Hollybrook

SEPTIC FIELD LAYOUT
LOT # 12

Hollybrook Subdivision Septic Specifications
Iredell County , NC

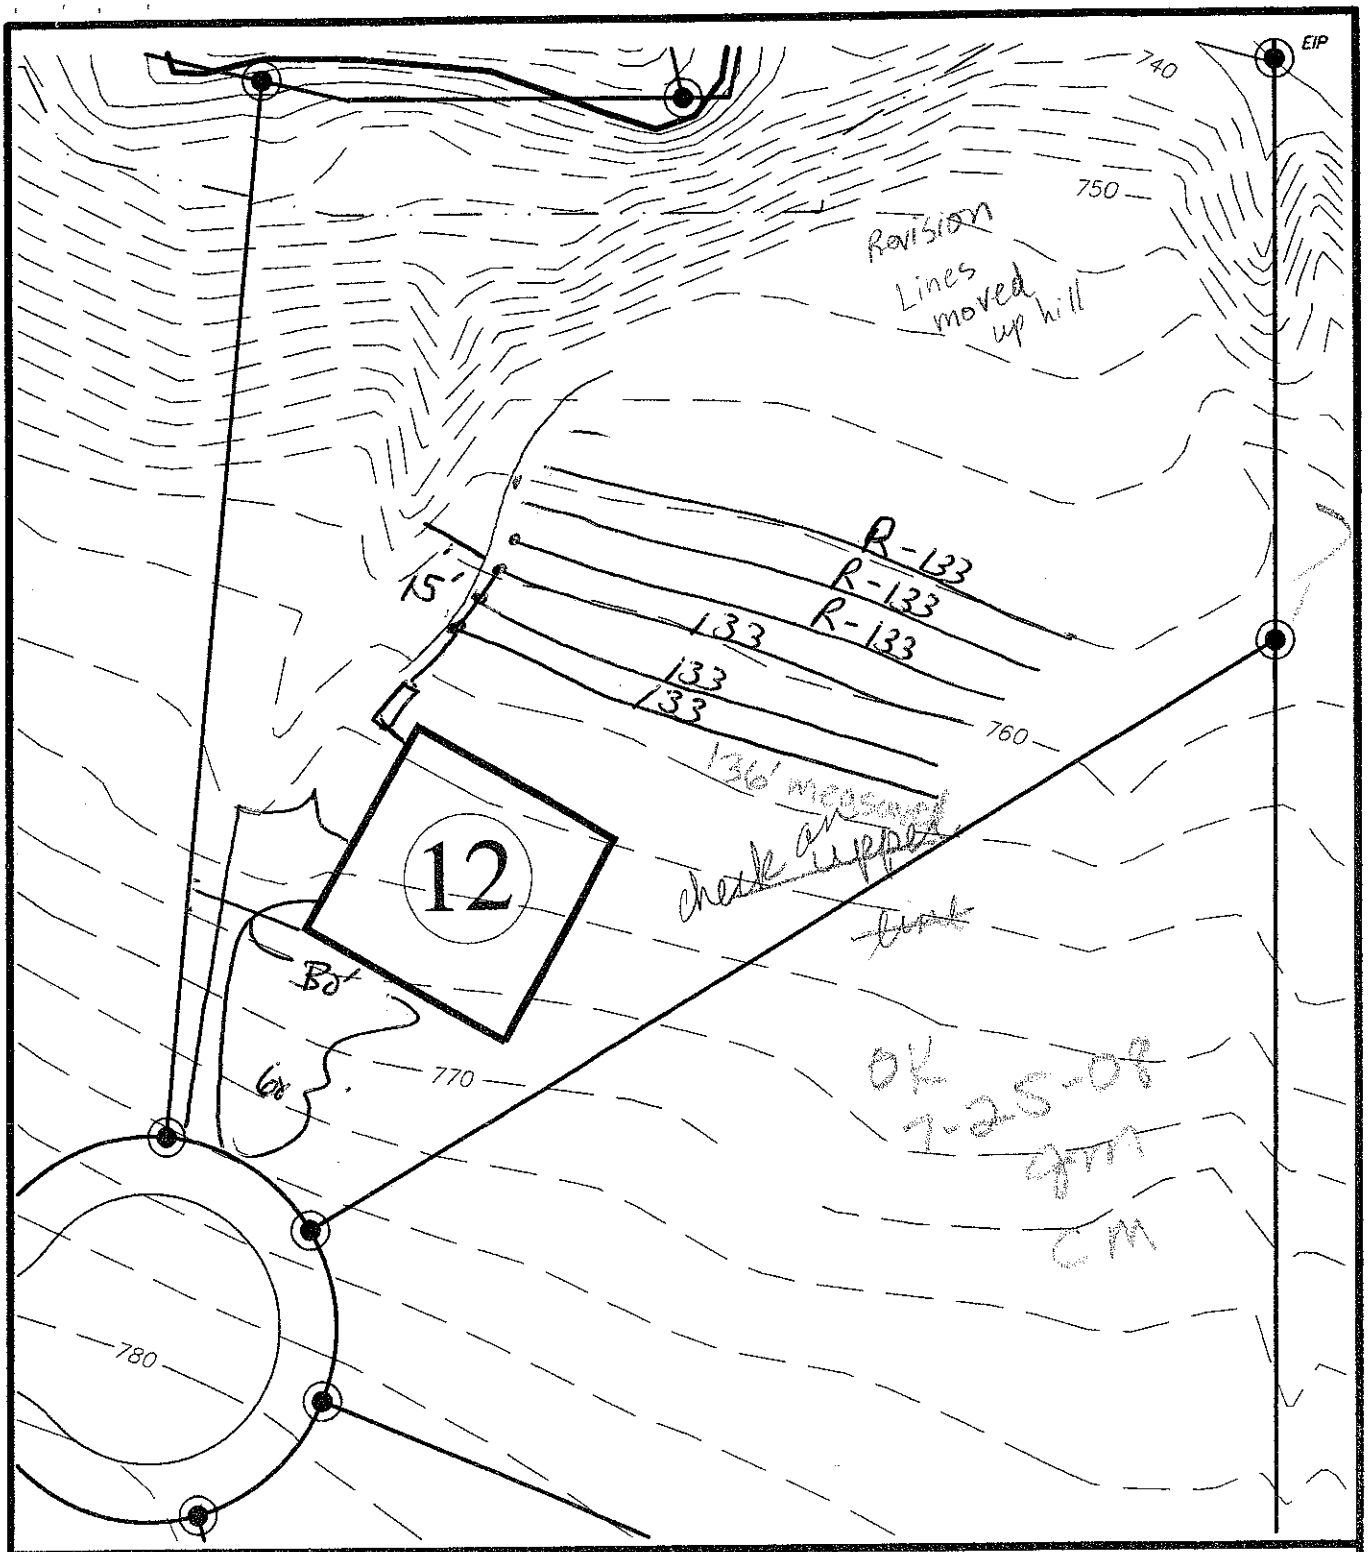
Number of Trenches 3 Trench Width and Length 3'x~~100'~~ 133'

OK to LYRE waterline

SOIL/SITE EVALUATION
for ON-SITE WASTEWATER SYSTEM

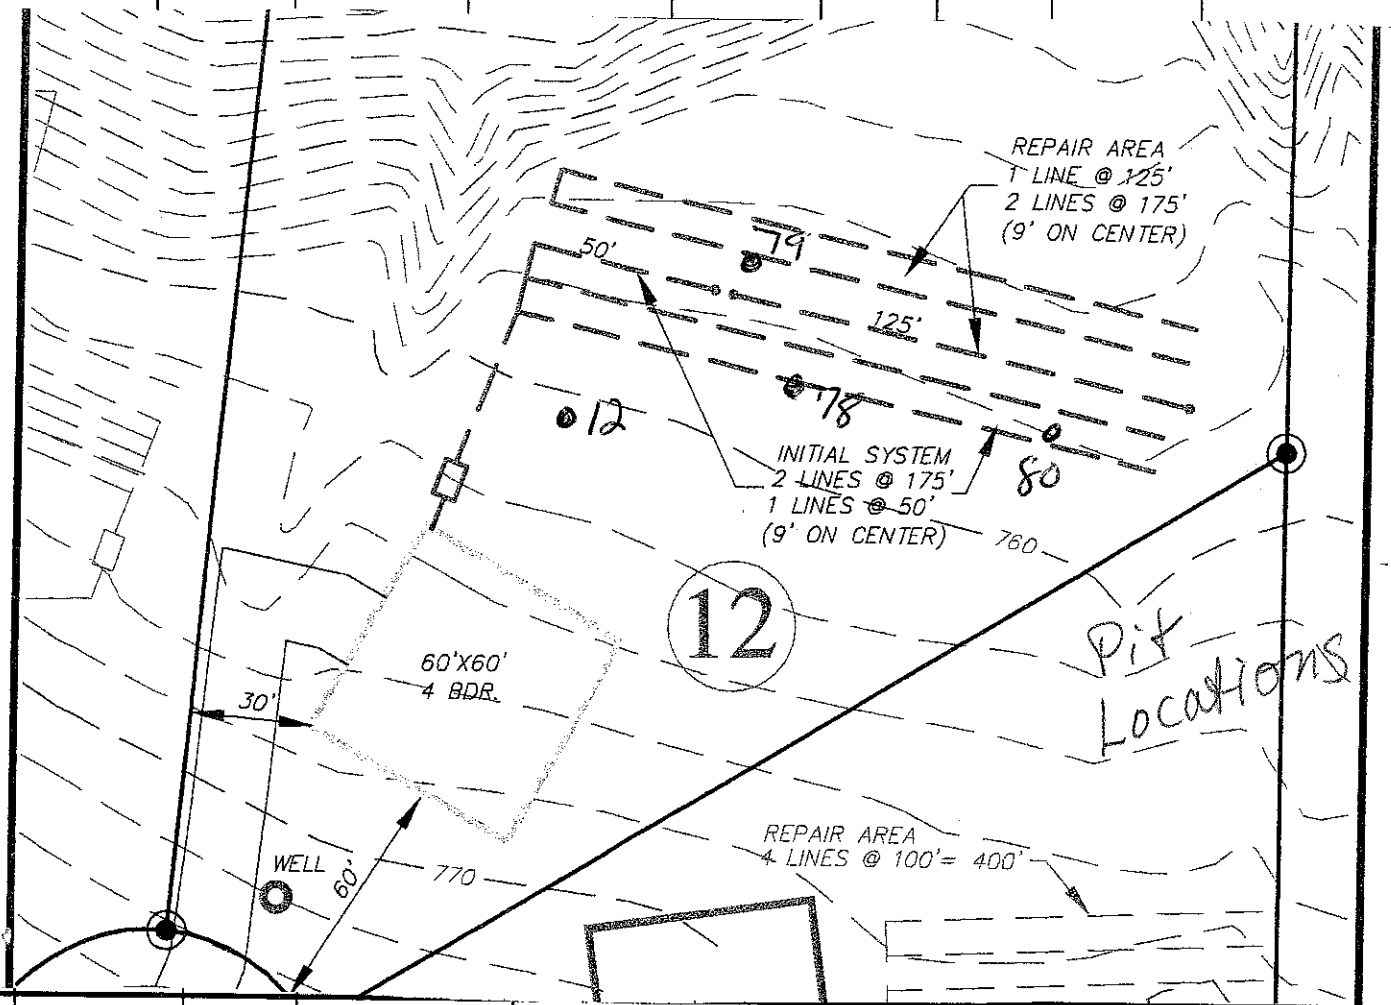
78	As 77	Ap 0-3	SBK	CL	SEXP FR S P	2.5YR 4/6	28"+ to CB	II Below 44"	28" to CB	III LPP ~~0-2 l/hr~~ or 0.5 l/hr sap ~~below 44"~~
		B+ 3-28	"	C	" " " "					
		CB 28-44	"	C/CL	" " " "					
		C 44-48+	SBK/GR	SL	" FR/VFR SS SP					
79	As 77	Ap 0-4	SBK	CL	SEXP FR S P	2.5YR 4/6	44"+ to sap	N/A	44" to sap	IV 0.3 l/hr
		B+ 4-44	"	C	" " " "					
		C 44-48+	"	CL/SL	" " " "					
80	As 77	Ap 0-3	SBK	CL	SEXP FR S P	2.5YR 4/6	40"+ to CB	N/A	40" to CB	III 0.3 l/hr
		B+ 3-24	"	C	" " " "					
		BC 24-40	"	C/CL	" " " "					
		CB 40-48+	"	CL/C	" " " "
